KDS Washing Plant

251-252, Nasirabad I/A, Baizid Bostami Road, Chattogram, Bangladesh
(22.392529, 91.819859)
15 September 2022

1. Block-B Building seven (G+6) reinforced concrete building.

Damaged Column

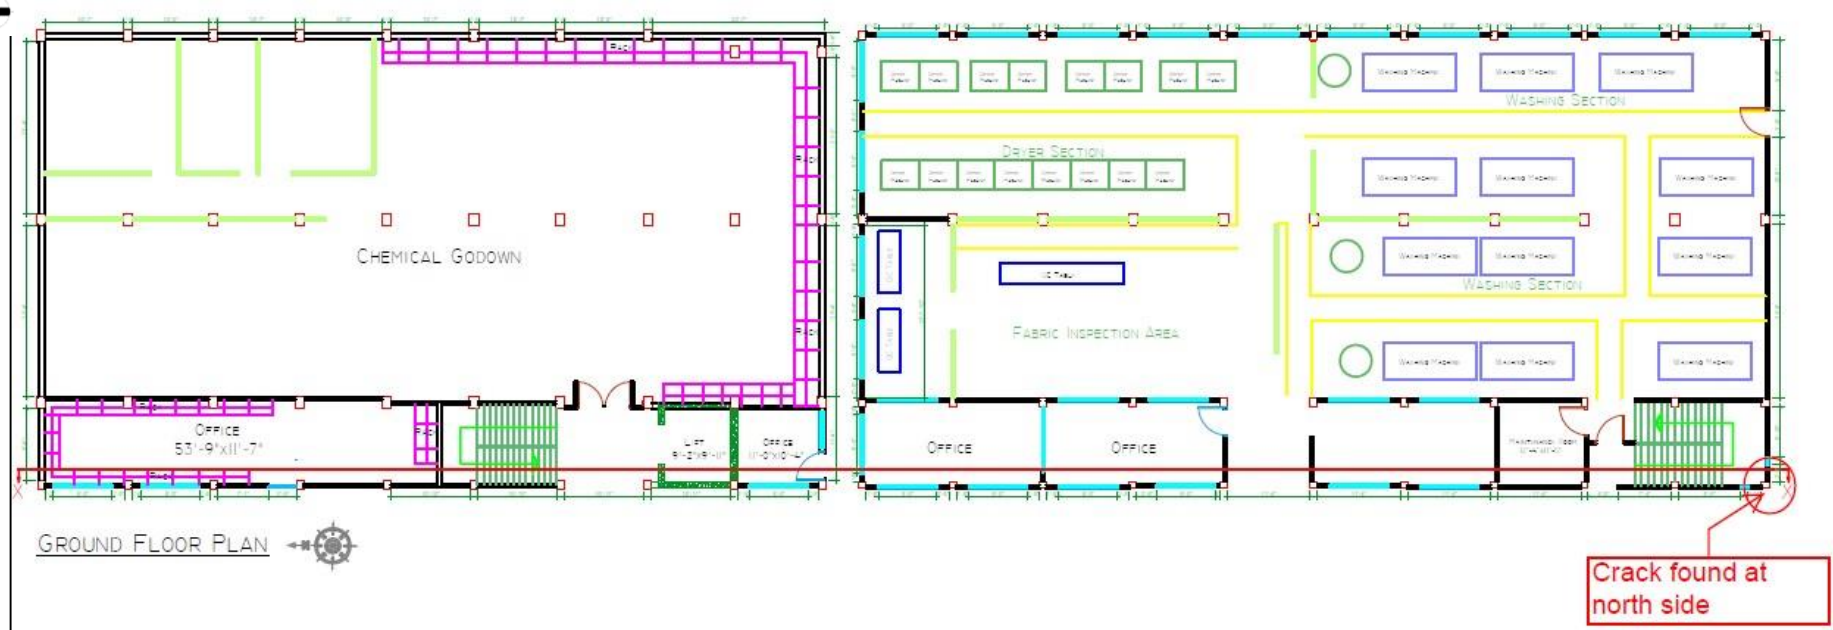
Damaged column was found on the south-west corner of the ground floor at the stair area (Marked in Figure-1) of the 7-storied factory Building (Block-B).

The factory must immediately engage a consultant to investigate the damaged column. Any safety measures, if required as suggested by the consultant must be taken immediately to ensure safety.

Beam Layout Plan

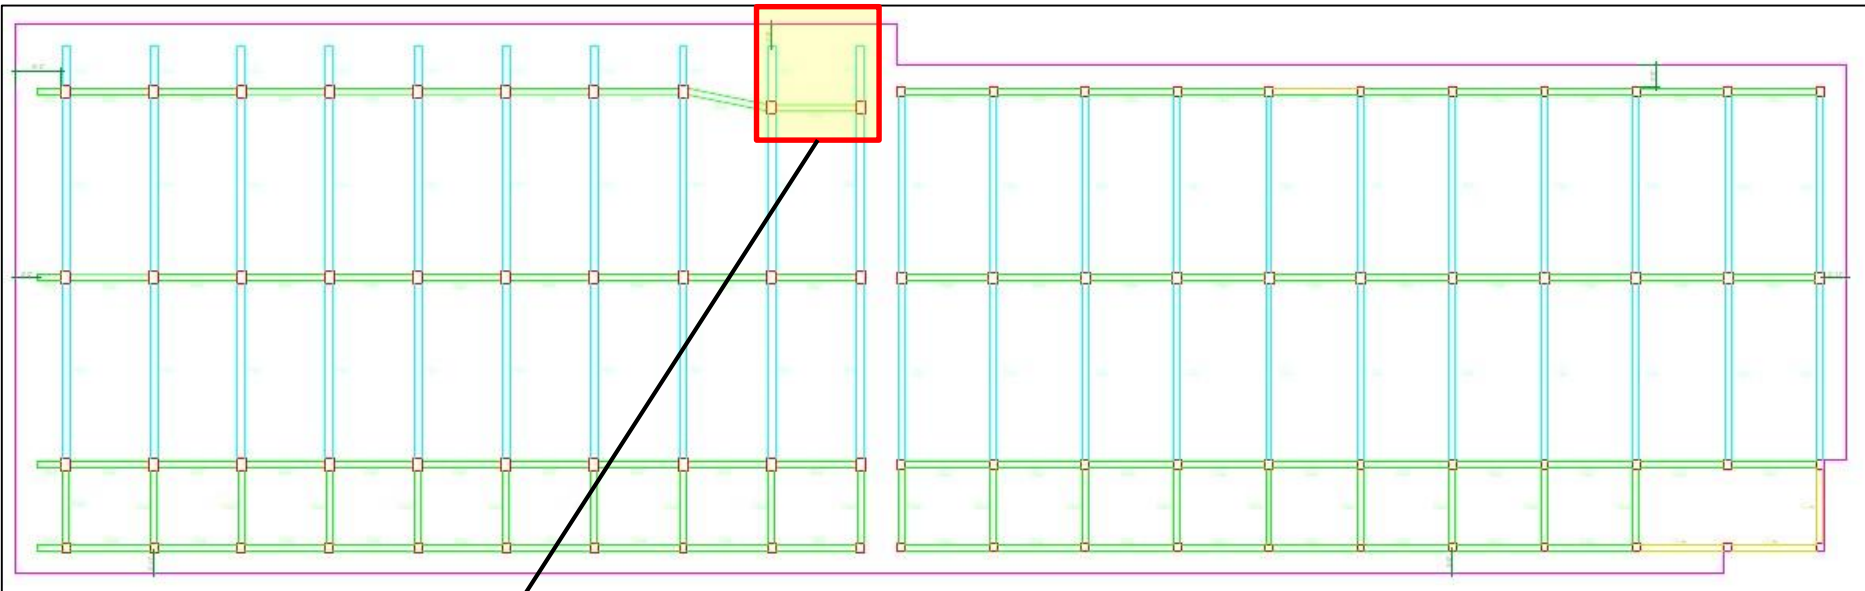
Undocumented toilet block was found at marked location. The toilet block was found with 225mm build up supported by cantilever beam. Factory engineer is required to update the as-built drawing and provide the adequacy of the cantilever beam and slab against the super imposed load from toiler block.
